## TECHNICAL NOTE

<b>Project Name</b>	Kintore Flood Study		
<b>Project No.</b>	4021839		
<b>Document Title</b>	Hydraulic Model Review Note		
<b>Issue Date</b>	21/03/25		
<b>Issue Status</b>	FINAL		
<b>Prepared</b>	<b>Checked</b>	<b>Reviewed</b>	<b>Approved</b>
<i>AG</i>	<i>JK</i>	<i>HB</i>	<i>HB</i>

Figure 3 – Subcatchments within Scottish Water model (at Kintore)

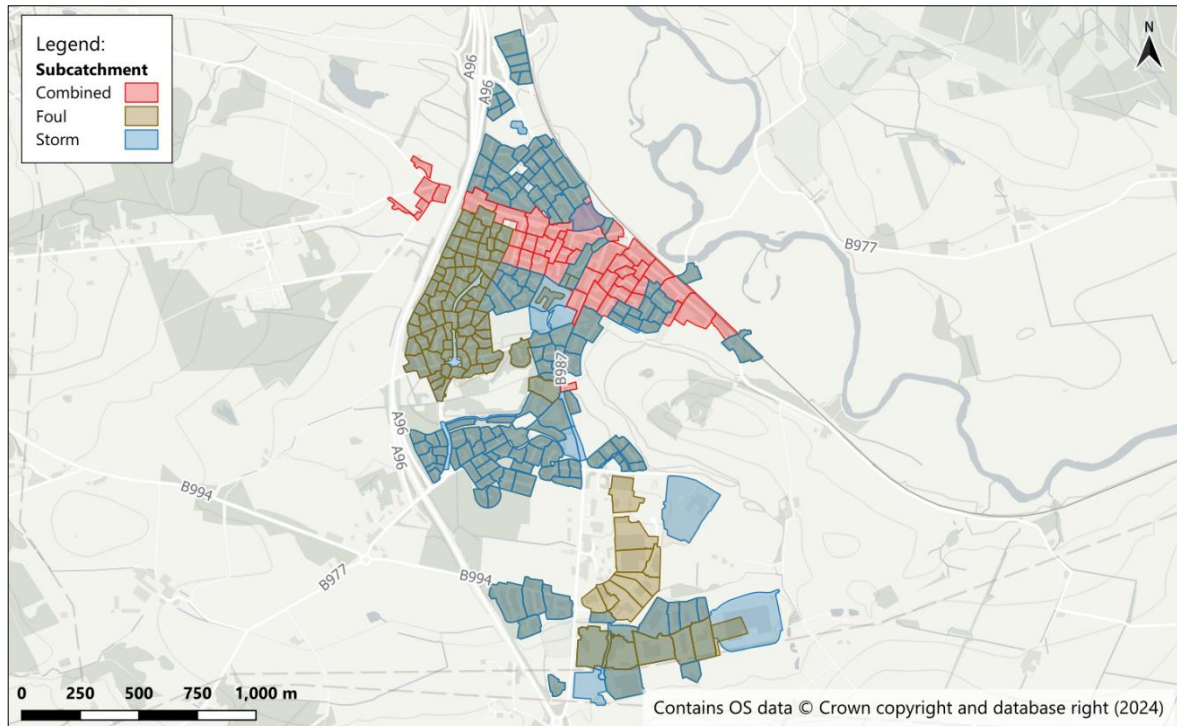
Figure 2 shows a schematic representation of the model to understand how generated flows are drained across Inverurie DOA. Figure 3 shows the extents of the subcatchments across Kintore. The total area of subcatchments were found to always equal the contributing area – hence, no account was made for ‘additional’ inflows from areas outside the defined subcatchments. While this was acceptable for the model build drivers, this situation is not considered suitable for an adequate representation to determine potential issues related with surface water. Therefore, some modifications are required to account for surface water flows from locations outside of the subcatchments areas represented in the provided model.

1. Apply storm, greenfield and ReFH subcatchments to remaining areas where they do not currently exist in the model and assign the appropriate parameters.
2. Represent the currently missing surface water networks and ditches not currently represented in the model.

Figure 4 – Scottish Water network model extents (at Kintore)

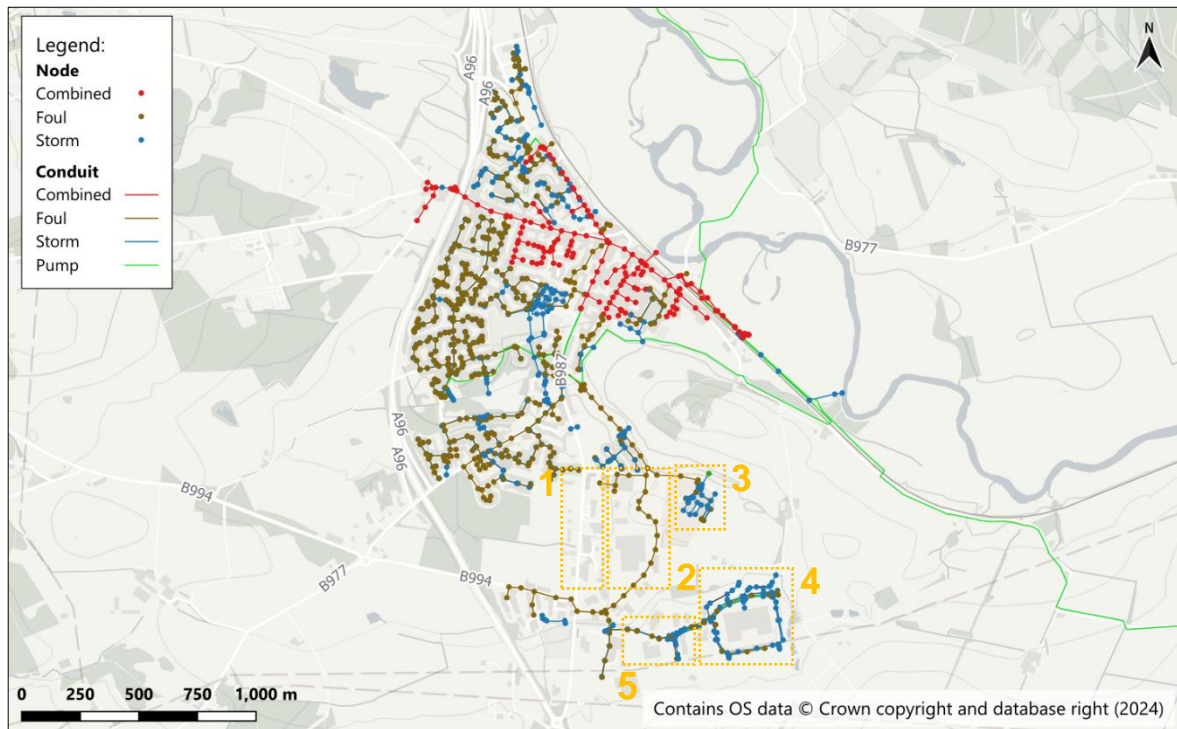
The 1D network primarily consists of a separate sewer system, with the older parts of the town being served by a combined sewer network. As shown in Figure 4, the network covers most of Kintore, but there are some areas where foul and storm water networks are not included in the model:

1. Missing foul and surface water along School Road (B987);
2. Surface water network Tumulus Way;
3. Foul network at Midmill Primary School;
4. Foul network at Toft hills Avenue; and
5. Missing surface water network section at Toft hills Avenue.

It is understood that information about these missing networks was not available during the model build process at the time of most recent model maintenance. Areas 1 and 2 are likely served by surface water networks draining into the drain crossing underneath these flowing from the west. Areas 3 and 4 are missing the foul subcatchments defining the generated wastewater flows; however, the foul sewer networks themselves are included in the model. In Area 5, a surface water network section ends abruptly at Toft hills Avenue with Newmill View. The exclusion of the foul subcatchments networks does not affect the purpose of the model for the flood study, although the lack of surface water networks reduces its accuracy. This information should be added if it is available.

Figure 6 – DTM source

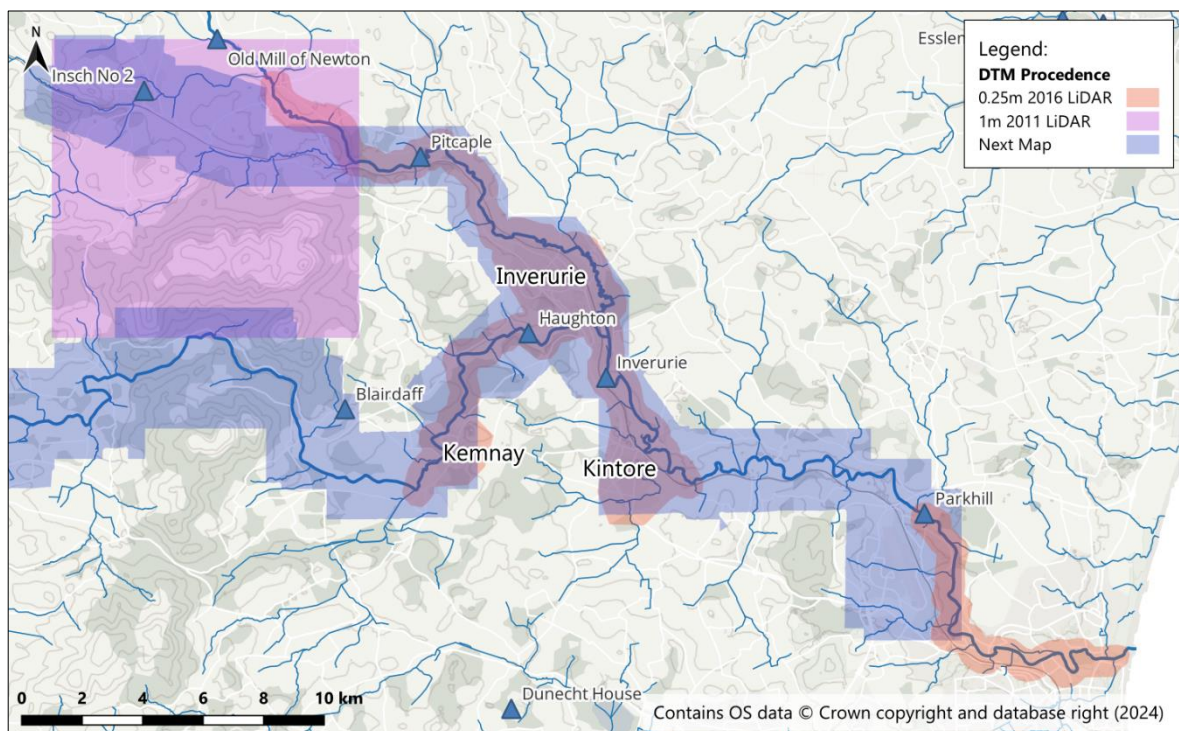
- The main source for the DTM was a combination of the 1m LiDAR and 25cm LiDAR shown in Figure 6 resampled by TUFLOW at the mentioned 4m grid resolution.
- The model includes urban areas, the buildings have been represented individually raising the DTM levels by 0.3m across the building footprint and are given a roughness value of 0.1. The buildings were defined using OS Master Map data. Doorstep threshold levels will be used to apply more accurate building upstands in the Kintore FPS modelling.
